Mary Ave Villas Project

Supplemental Report

CITY COUNCIL STAFF REPORT SUPPLEMENTAL

Agenda Item #8

SECTIONS C005.0

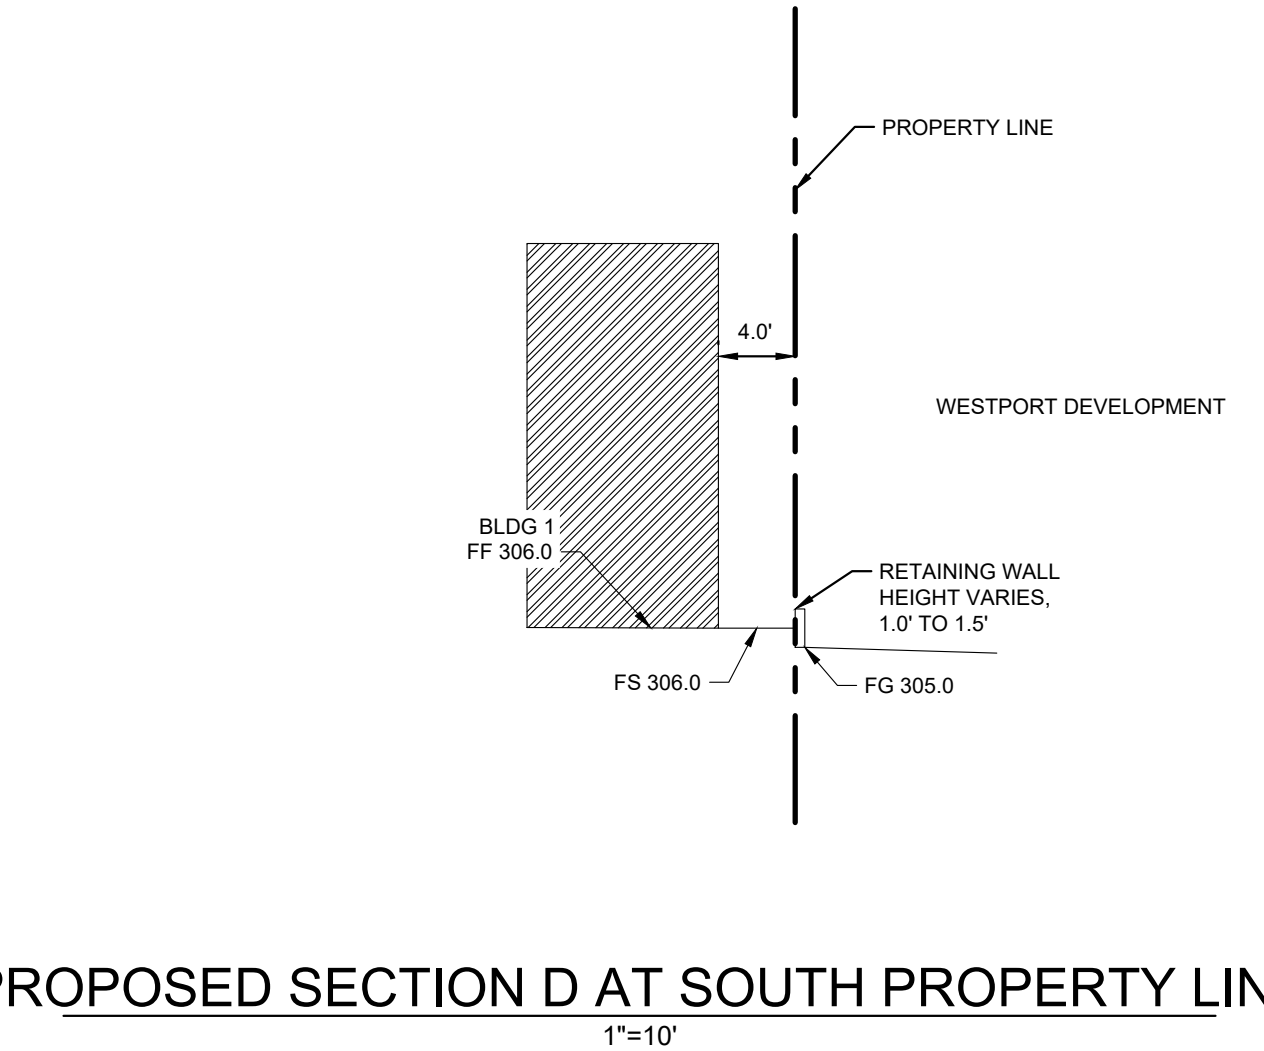
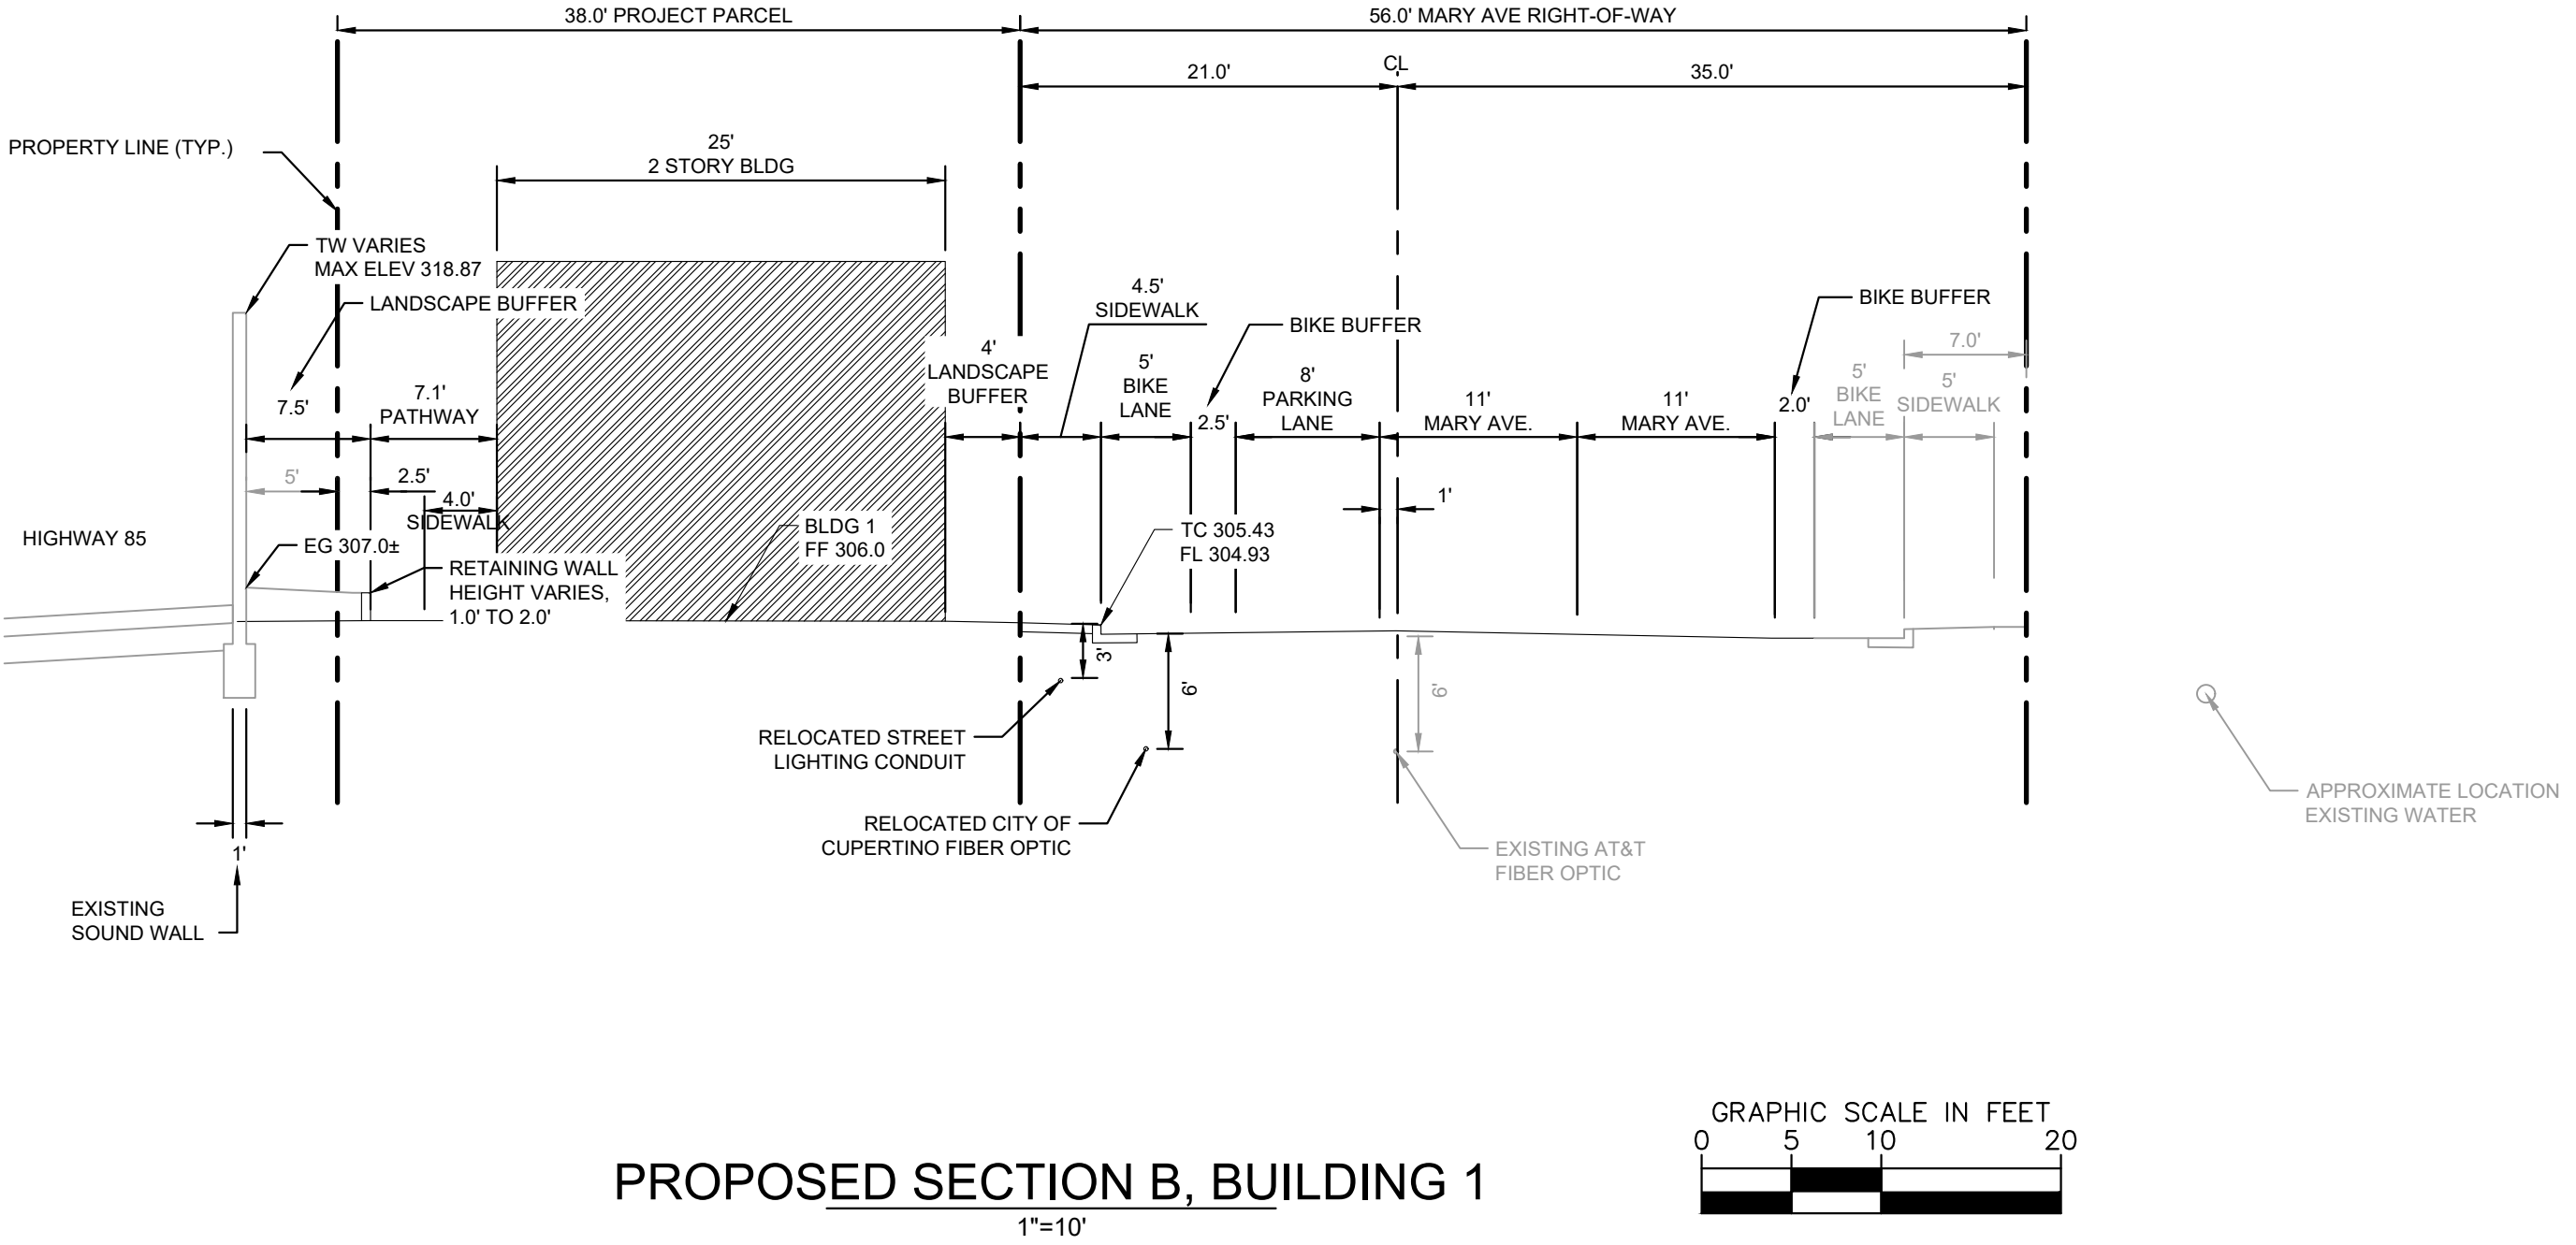
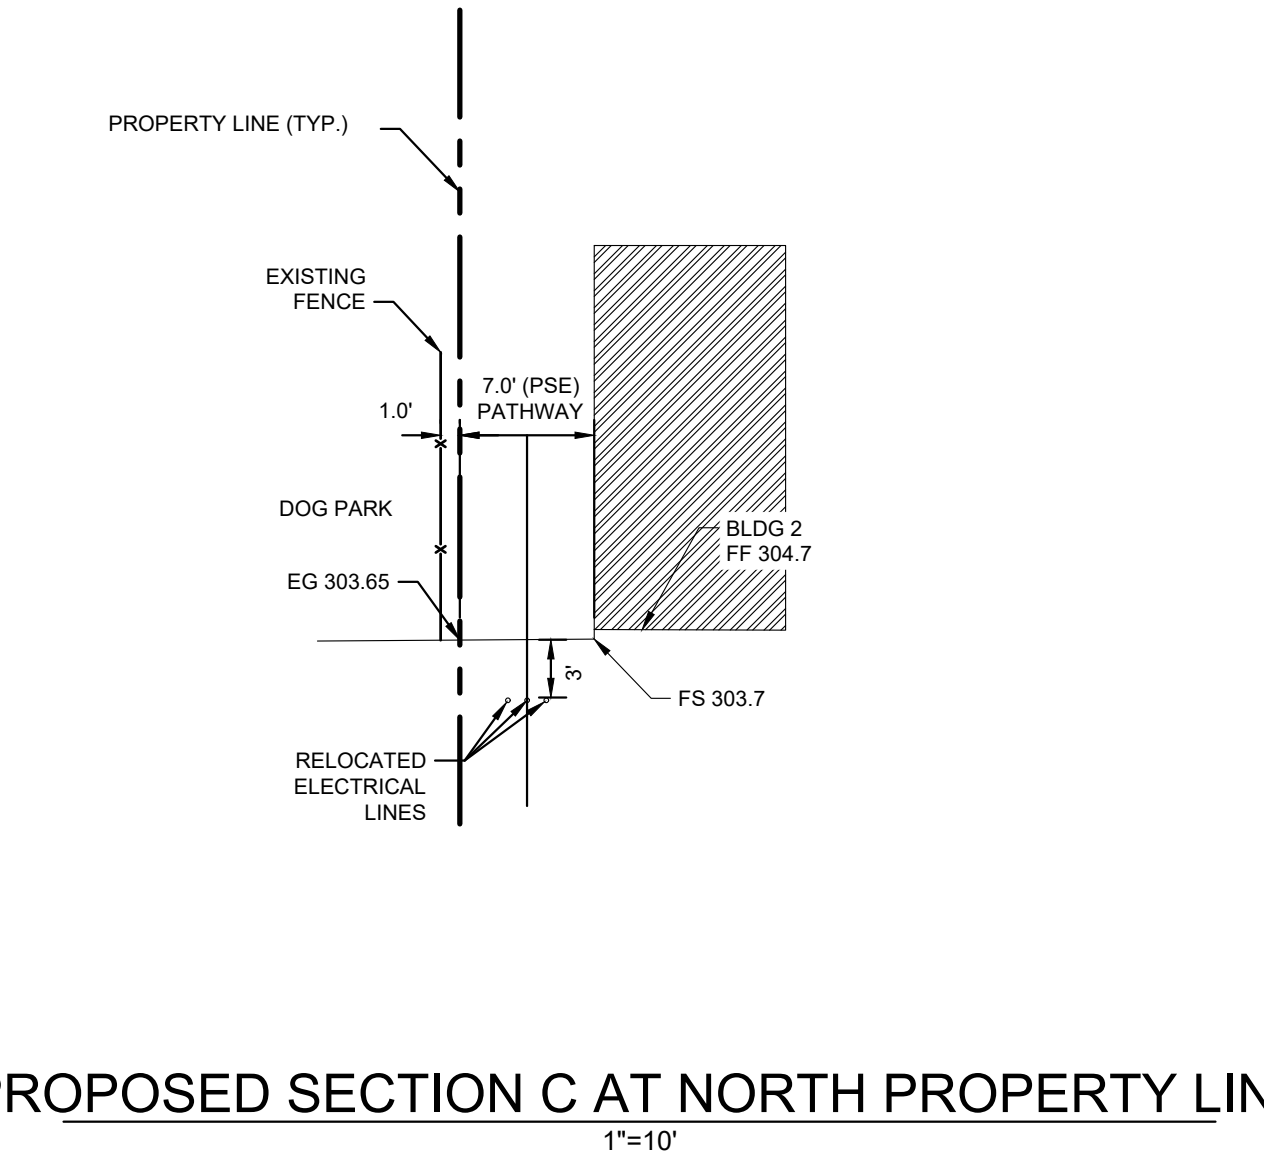
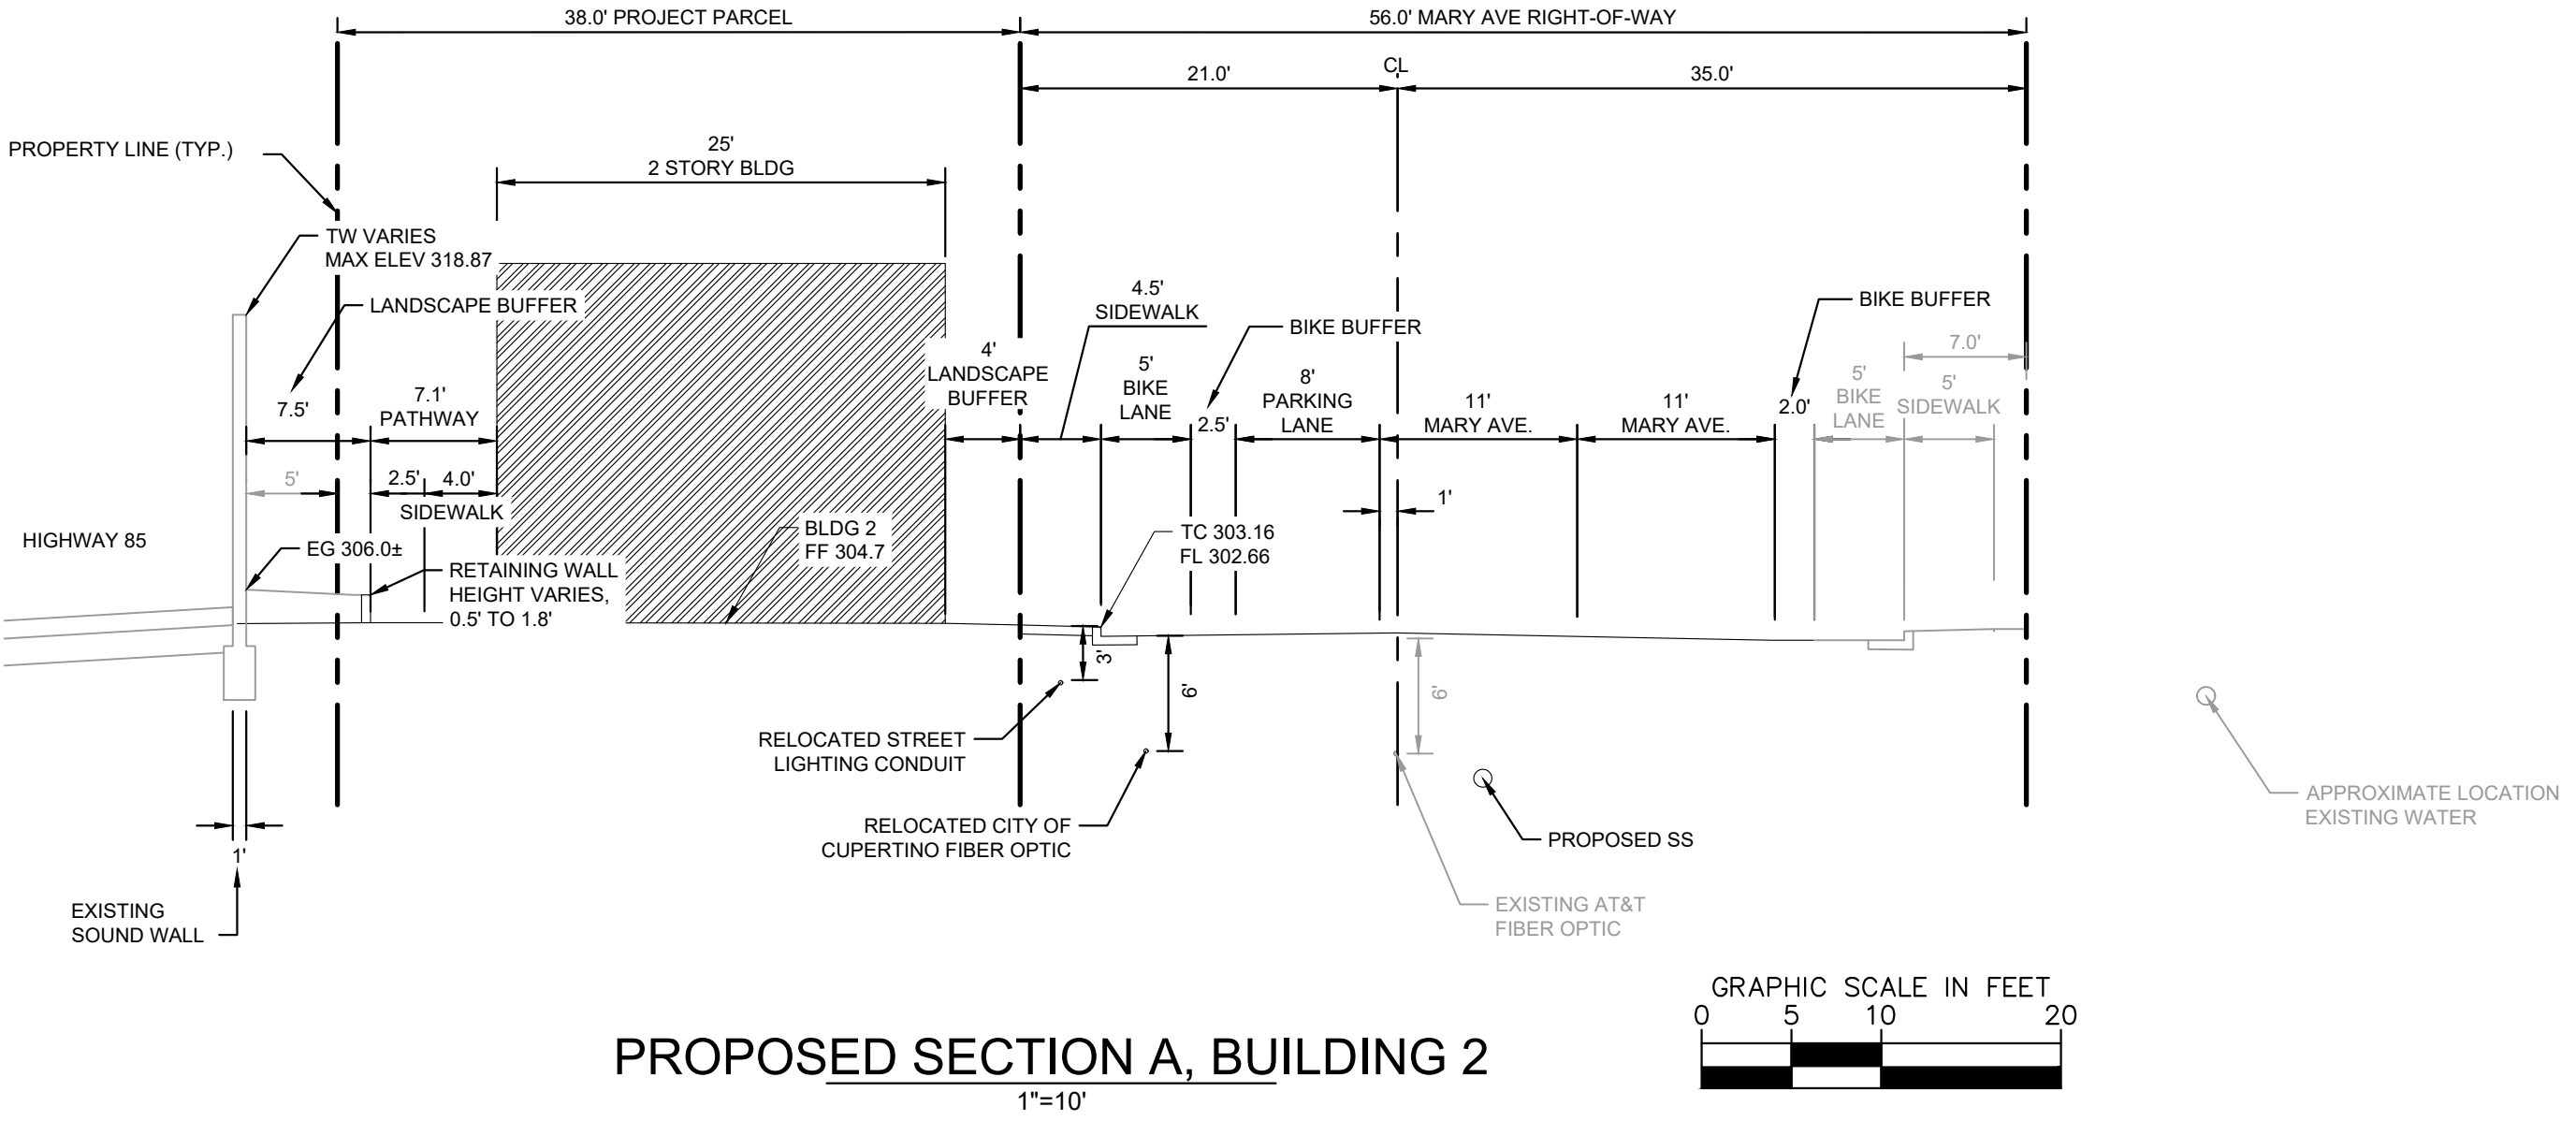
Q4: What exactly would be reconfiguration of the Mary Avenue? Please provide clear images for before and after.

Staff response: The Plan Set provided with the Staff Report (Attachment F) showed the existing conditions as well as the proposed layout of the Mary Avenue Right-of-Way. Supplemental Attachment G shows sheets C000.0 (Existing Conditions and Demolition Plan), C001.0 (Preliminary Site Plan), and C005.0 (Sections), which had been included in the Plan Set that had been provided with the Staff Report.
